Access Compliance Report

Public Rights-of-Way

Intersection ID: 10035532	Main Street: REA_RD	Cross Street: N/A	Location: SW
ADA ID: 67047796B55D	Ramp Type: BlendTrans1	Initial Pass/Fail: Fail	Overall Compliance: No
		Severity Score: 1.25

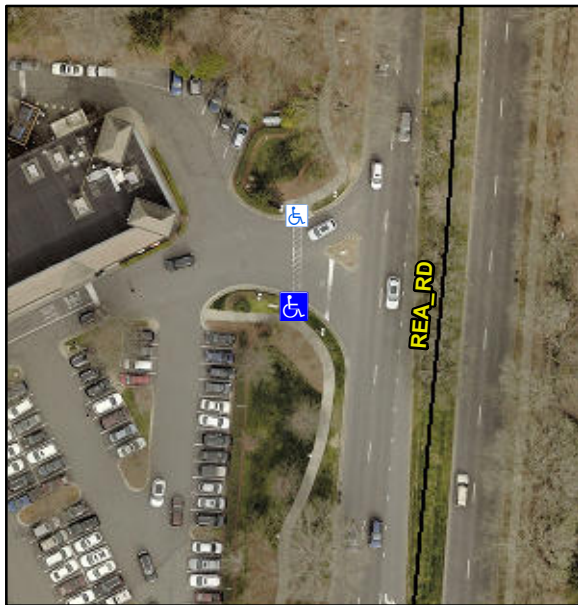
Not Found, R304.5.3

Compliance	Description	Data	Compliance	Description	Data
N/A	Ramp Length (in)	73.0	Yes	BlendTrans Slope (%)	3.3
Yes	Ramp Width (in)	48.0	No	BlendTrans XSlope (%)	3.7
N/A	Flare Type LT	N/A	N/A	Flare Type RT	N/A
N/A	Flare Slope LT (%)	N/A	N/A	Flare Slope RT (%)	N/A
N/A	Flare Traversable LT?	N/A	N/A	Flare Traversable RT?	N/A
N/A	Landing Length (in)	N/A	N/A	DWS Provided?	N/A
N/A	Landing Width (in)	N/A	N/A	DWS Contrast?	N/A
N/A	Landing Slope (%)	N/A	N/A	DWS Length (in)	N/A
N/A	Landing X Slope (%)	N/A	N/A	DWS Full Width?	N/A
N/A	Landing Curb? (Y/N)	N/A	N/A	DWS Offset (in)	N/A
N/A	Shared Landing?	N/A			
N/A	Gutter Ponding?	N/A	N/A	Gutter Slope (%)	N/A
N/A	Gutter Lip Ht (in)	N/A	N/A	Gutter X Slope (%)	N/A
N/A	Painted X Walk1?	Yes	N/A	Painted X Walk2?	N/A
	X Walk 1 Direction	To N		X Walk 2 Direction	N/A
	X Walk 1 Width (in)	48.5		X Walk 2 Width (in)	N/A
	X Walk 1 Slope (%)	4.6		X Walk 2 Slope (%)	N/A
	X Walk 1 X Slope (%)	5.6		X Walk 2 X Slope (%)	N/A

Remove & Replace Curb Ramp With Two New Directional Ramps or Equivalent.
